BNC Ref. DA144-23 AM Ref. RAL/23/0085 SARA Ref. 2401-38533 SRA

RE: APPLICANT RESPONSE TO ASSESSMENT MANAGER & REFERRAL AGGENCY INFORMATION REQUEST RECONFIGURING A LOT DEVELOPMENT APPLICATION (ONE (1) INTO TWO (2) LOTS SUBDIVISION) 41634 BRUCE HIGHWAY, BLUEWATER QLD 4818 (RPD: LOT 73 ON EP1620)

# RE: 41650 BRUCE HIGHWAY, BLUEWATER – RESPONSE TO INFORMATION REQUEST IN RELATION TO RECONFIGURATION OF AN ALLOTMENT RAL23/0085

Figure 3-1 Proposed site layout

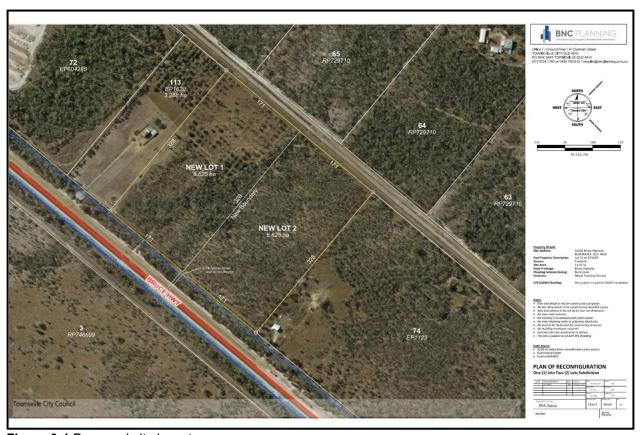
- Issue 1 Proposed development must demonstrate that the road access location and design is appropriate for the intensified access.
  - Identify all vehicle types anticipated to be used as part of the development.
  - Swept path movements to prove dimensions and positioning are adequate for expected traffic.
  - Intersection turn warrant assessment to assess required turn treatment.
  - Safety audit of adjacent road network.
  - Sight-line assessment for adjacent traffic and cyclists/pedestrians.
  - Updated concept plans to be in accordance with TMR's standard drawing for rural property access and any mitigation measures required.

The proposed development consists of a one (1) into two (2) lot subdivision which includes the construction of a proposed dual access at the location of the new shared boundary.

Detailed Design Property Access Plans – Developed by NCE – Dated 08/02/2024

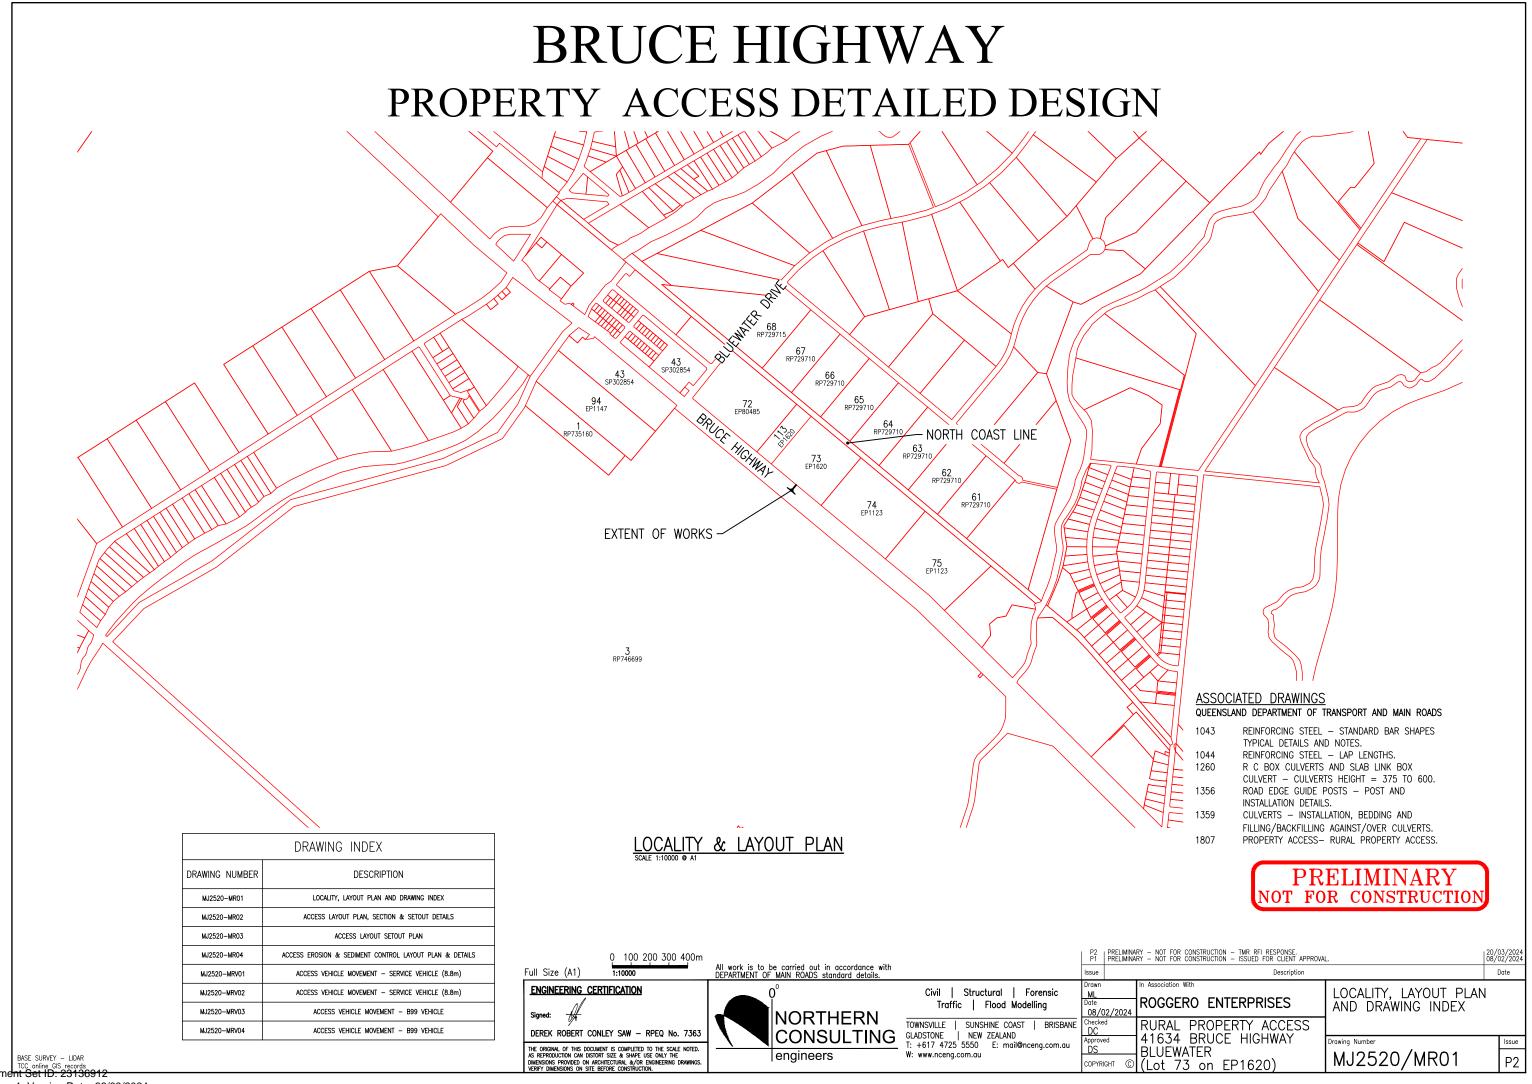
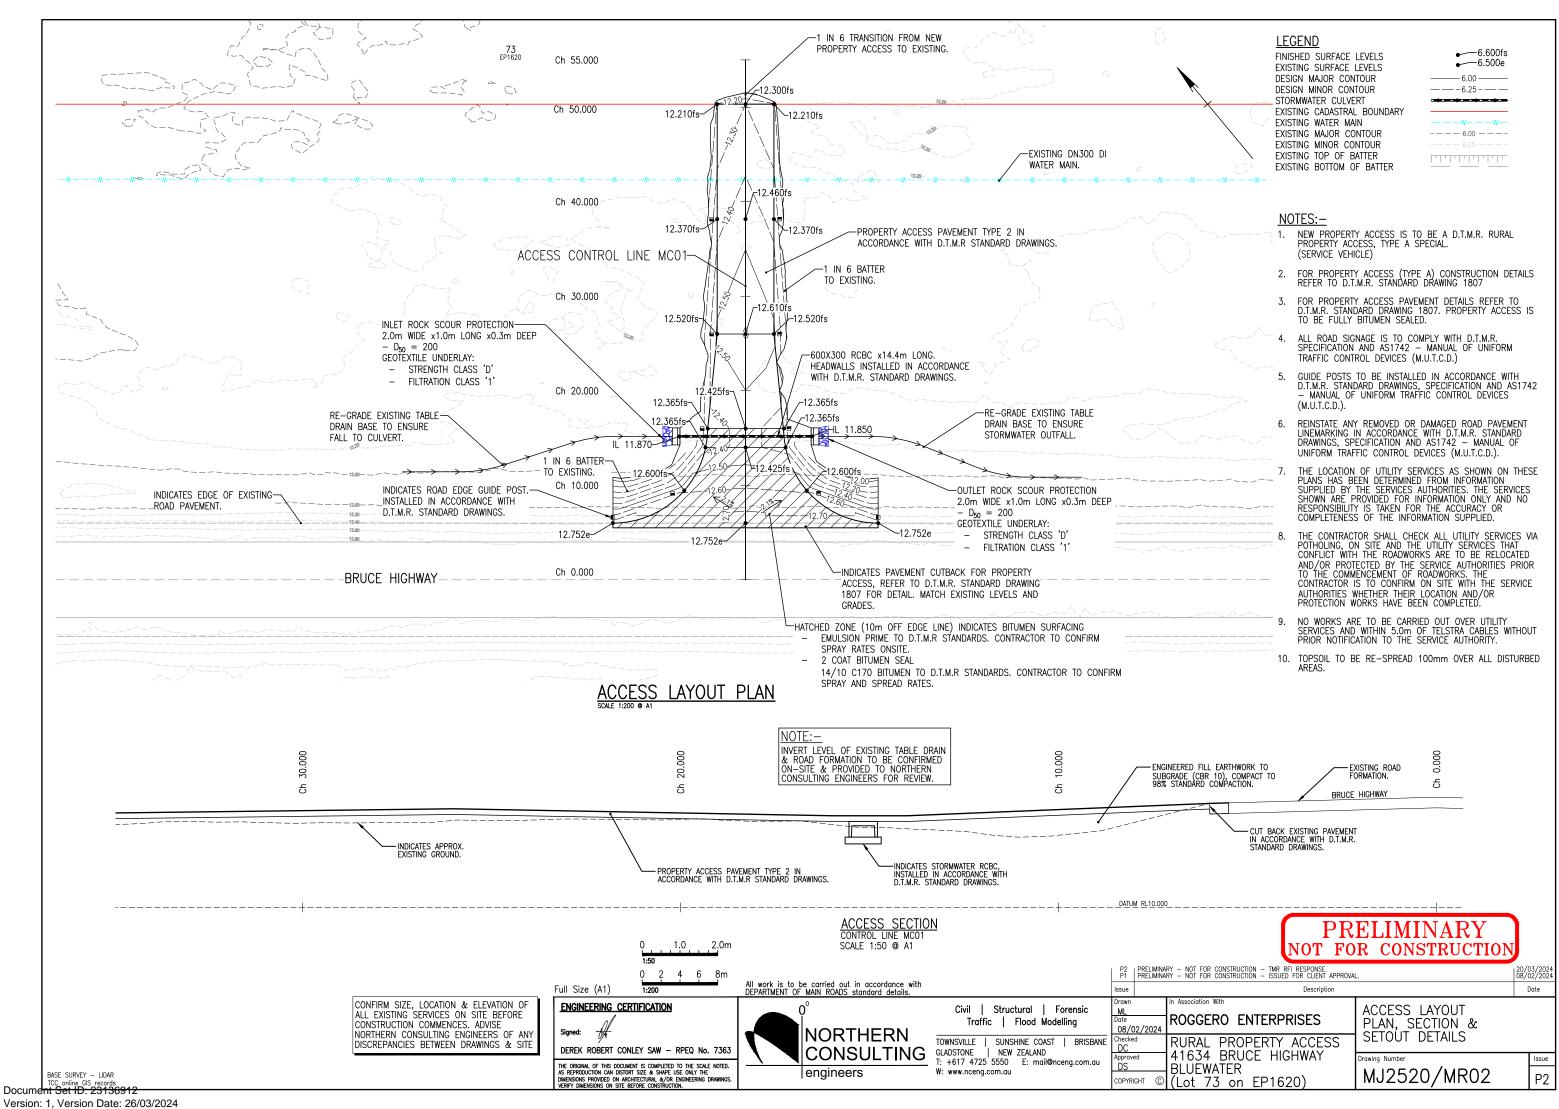
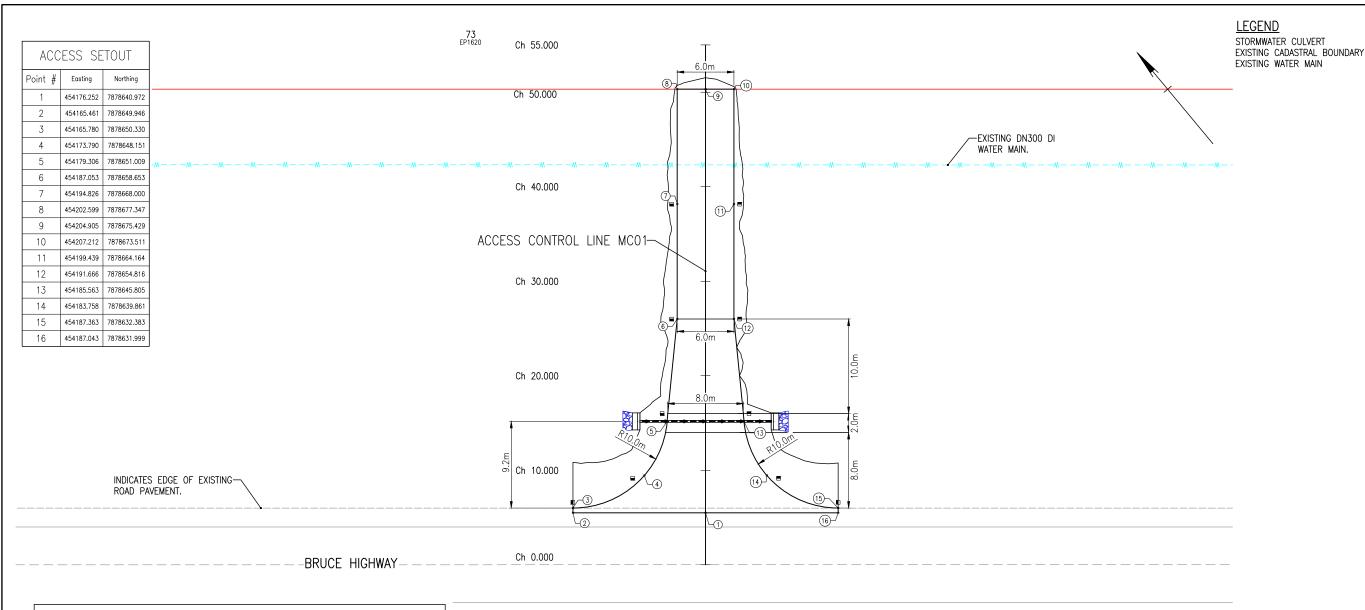
- f) Provide concept plans in accordance with TMR's standard drawing for rural property access, identifying the proposed road access works and any required mitigation measures such as turn treatments.

- Updated concept plans to be in accordance with TMR's standard drawing for rural property access and any mitigation measures required.
    - The Appendices contain updated access plans with dimensions which have been drawn in accordance with TMR's standard drawing for rural property access.
